[Docket No. FAA-2004-19969; Directorate Identifier 2004-SW-43-AD; Amendment 39-13923; AD 2004-26-11]

Airworthiness Directives; Bell Helicopter Textron Canada Model 222, 222B, 222U, 230, and 430 Helicopters

ACTION: Final rule; request for comments.

AD 2004-26-11 Bell Helicopter Textron Canada: Amendment 39-13923. Docket No. FAA-2004-19969; Directorate Identifier 2004-SW-43-AD.

Figure 1. Blade inspection area

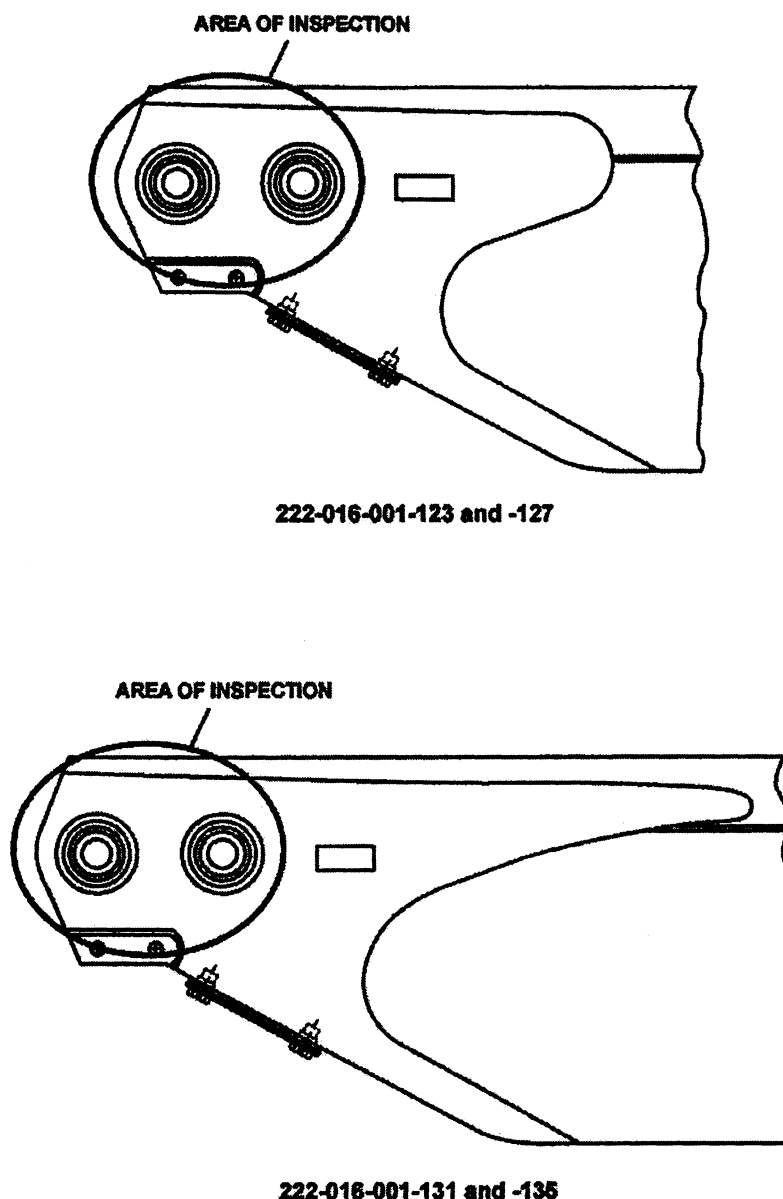
- (a) Within 3 hours time-in-service (TIS) and at intervals not to exceed 3 hours TIS, clean and visually check both sides of each blade for a crack in the paint in the areas shown in Figure 1 of this AD. An owner/operator (pilot), holding at least a private

wiping down both surfaces of each blade in the inspection area depicted in Figure 1 of this AD using aliphatic naptha (C-305) or detergent (C-318) or equivalents. Using a 10X or higher power magnifying glass, visually inspect both sides of the blade in the areas depicted in Figure 1 of this AD.

(1) If even a crack is found in the paint, before further flight, remove the blade.

(2) Remove the paint to the bare metal in the area of the suspected crack by using Plastic Metal Blasting (PMB) or a nylon web abrasive pad. Abrade the blade surface in a span-wise direction only.

(3) Using a 10X or higher power magnifying glass, inspect the blade for a crack.

(i) If a crack is found, before further flight, replace the blade with an airworthy blade.

(ii) If no crack is found in the blade surface, refinish the blade by applying one coat of MIL-P-23377 or MIL-P-85582 Epoxy Polyamide Primer so that the primer overlaps

the existing coats just beyond the abraded area. Let the area dry for 30 minutes to 1 hour. Then, apply one sealer coat of Polyurethane MILC85285 TYI CL2, color Number 27925 (semi-gloss white) per Fed. Std. 595. Reinstall the blade.
